Detailed Site Plan Alternative Compliance Spirit of God Deliverance Church

**DSP-21012
AC-21020**

STAFF REPORT

SUBJECT: Detailed Site Plan DSP-21012
 Type 2 Tree Conservation Plan TCP2-043-2021
 Alternative Compliance AC-21020
 Spirit of God Deliverance Church

Figure 1: Site Plan

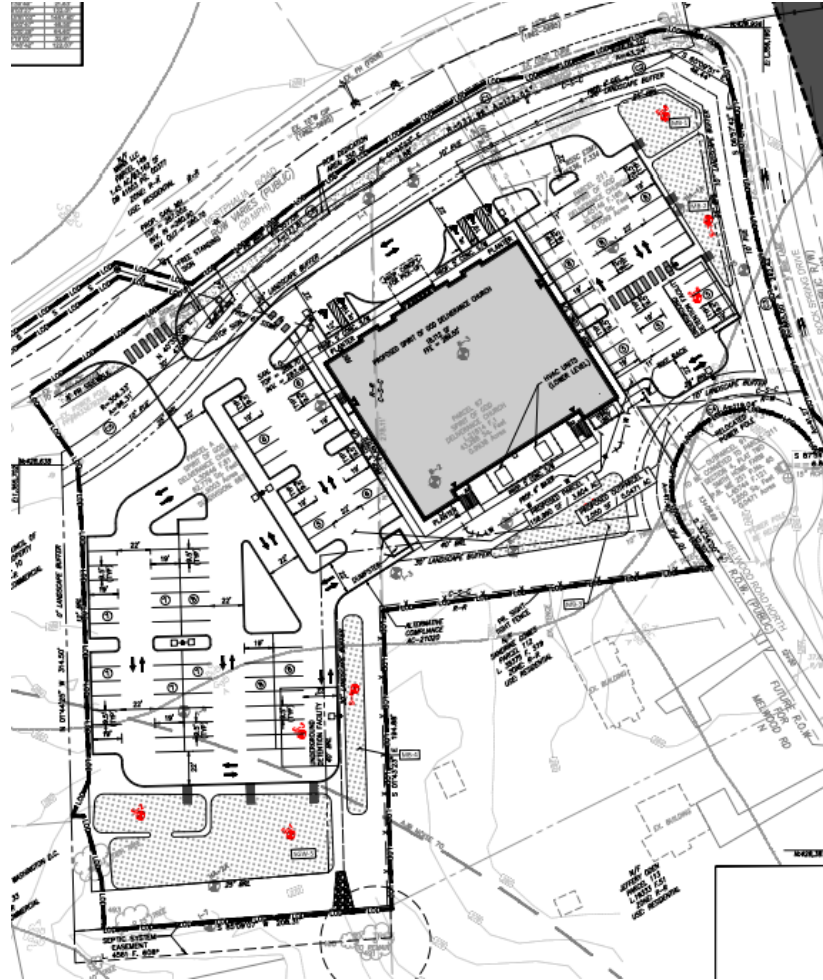
Note: *The site plan does not show the required loading space. Therefore, a condition has been included herein requiring it be added.

Continental style crosswalks and associated perpendicular ADA curb ramps are shown crossing the building entrance along Westphalia Road. However, the DSP does not show any crosswalks at the intersection of Rock Spring Drive and Westphalia Road. No entrances are proposed along Rock Spring Drive. A condition is included herein, requiring the additional crosswalks to be shown.

One bike rack is located at the southeast side of the proposed building, but no bike racks are proposed near the building entrance. Therefore, a condition is included herein, requiring the plan be revised to be in conformance with this requirement.

- g. Revise the site plan to show the required loading space.
 - h. Revise the proposed signage to conform to Section 27-617 of the Prince George's County Zoning Ordinance, which may include removing one sign, and to move any freestanding signs outside of any public utility easements.

- i. Provide notes on the site plan demonstrating conformance to Section 27-442 and Section 27-462 of the Prince George's County Zoning Ordinance, Regulations for the Rural Residential and Commercial Shopping Center Zones.
 - j. Provide a minimum of two bicycle parking racks closer to the building entrance.
 - k. Revise the DSP to show continental style crosswalks and associated perpendicular Americans with Disabilities Act curb ramps at the intersection of Rock Spring Drive and Westphalia Road, unless modified by the Prince George's County Department of Permitting, Inspections and Enforcement, with written correspondence.
 - l. Clarify the fence label on the site plan to include indication of height and type and reference to the applicable detail.
 - m. Label the handicapped van space on the plan.
 - n. Provide the following site plan notes:

- o. Indicate existing and proposed fire hydrants, with one being located within 200 feet of the proposed Fire Department Connection (FDC). Demonstrate that no exterior portion of the building will be more than 500 feet from a fire hydrant, as hose is laid by the Fire Department. The FDC should not be located on the east side of the building, as the drive aisles do not provide fire access.

- p. Revise the eastern parking lot to demonstrate conformance to Section 27-560 of the Prince George's County Zoning Ordinance, relative to required driveway widths.
